Project: IEEE P802.15 Working Group for Wireless Personal Area Networks (WPANs)

Submission Title: [Resolutions to Comments on CMS and Preambles] Date Submitted: [September 2008] Source: [R. Funada, M.A Rahman, C.S Sum, T. Baykas, J. Wang, M. Umehira, H. Harada, S. Kato(1), I. Lakkis(2)] Company [(1) NICT, (2)Tensorcom] Address [] Re: []

Abstract: [Resolutions to Comments on CMS and Preambles]

• Results

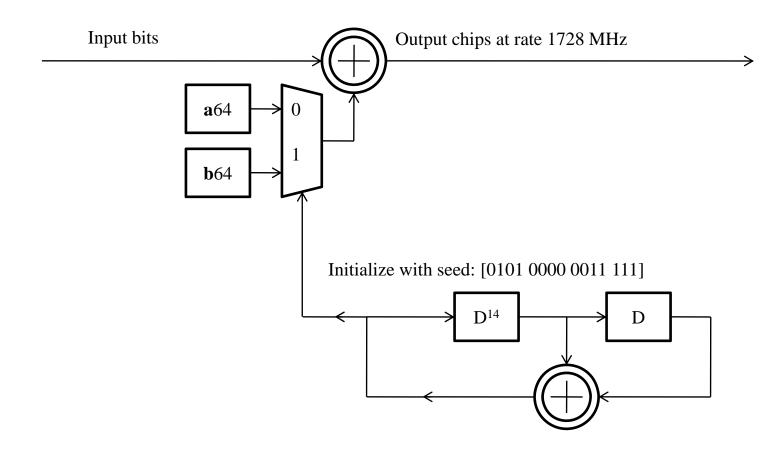
- Comment 447, 463: Improve Common Mode Signaling Performance
- **Resolution:**
- Payload and Header: 3dB improvement
 - By changing Spreading length from 32 to 64
 - Use a64 or b64 based on LFSR with known initial state at both transmit and receive.
- Long Preamble: 4.7 dB improvement
 - SYNC: Change from 32 repetitions of s128 to 64 repetitions of s128
 - SFD: Change from 1+3 repetitions by s128 to 8 repetitions [-1 -1 -1 1 -1 1 -1 -1] spread by s128
 - CES : Change from $a_{pre} a_{256}(8 \text{ times}) a_{pos} b_{pre} b_{256}(8 \text{ times}) b_{pos}$
- CCA: 6 microseconds
- Header for data:
- Choosing header spreading to 64 greatly diminish efficiency of the total system. To increase efficiency of the system choose the other header spreading rates to 8 and 2.

- Link Budget with improved CM:
- Assumptions
 - NF = 8 dB,
 - GTx = GRx = 3dB, (antenna gains)
 - Propagation Loss Index = 2.5
 - Shadowing margin= 5dB
 - Implementation loss = 1.5dB

- Payload Range with Spreading Factor 64 and concatenated RS(255,239), Hamming(12,8) code is 10 m
- Link Margin = 1.3 dB
